From: [J Shearin](#)
To: [City of Cupertino Bike and Ped Commission](#)
Cc: [David Stillman](#)
Subject: Vision Zero: please make changes before it is approved
Date: Thursday, March 28, 2024 6:25:05 PM
Attachments: [pastedGraphic.png](#)
[pastedGraphic_1.png](#)

I ask that you do not approve this report tonight at the commission meeting. The study needs some major updates and should come back to this commission again, preferably very soon, before it is approved.

figure 2.

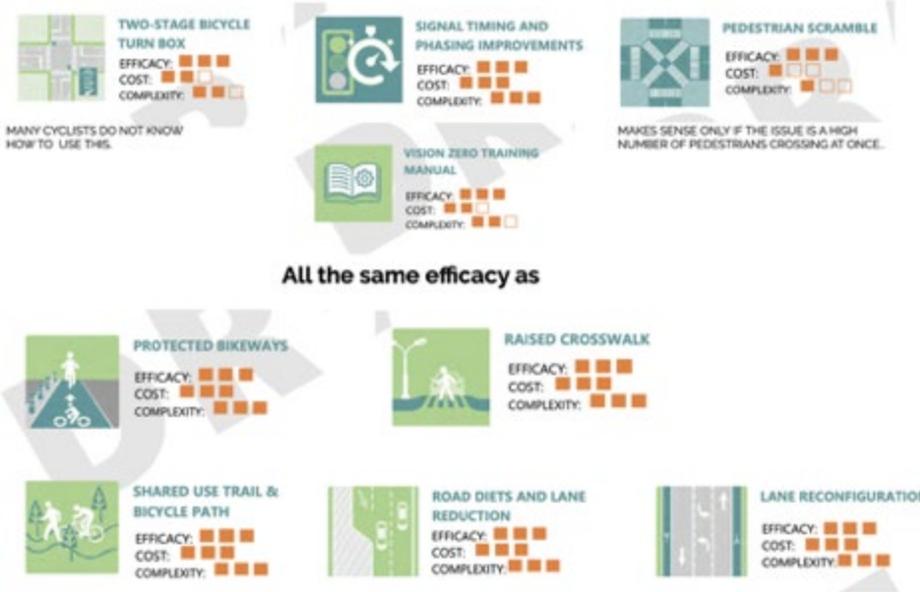
A major concern is the countermeasures toolbox and its ratings. The ratings seem arbitrary, especially efficacy, and at times unrelated to the latest studies or costs. No data is shown to demonstrate the ratings are accurate. One example is the efficacy rating of three blocks shown below in fig 2.

A two -stage bicycle turn box and a training manual is rated as highly as protected bike lanes. Many cyclists do not even understand how to use a two-stage bicycle turn box. To claim these three items have the same efficacy does not seem reasonable or likely.
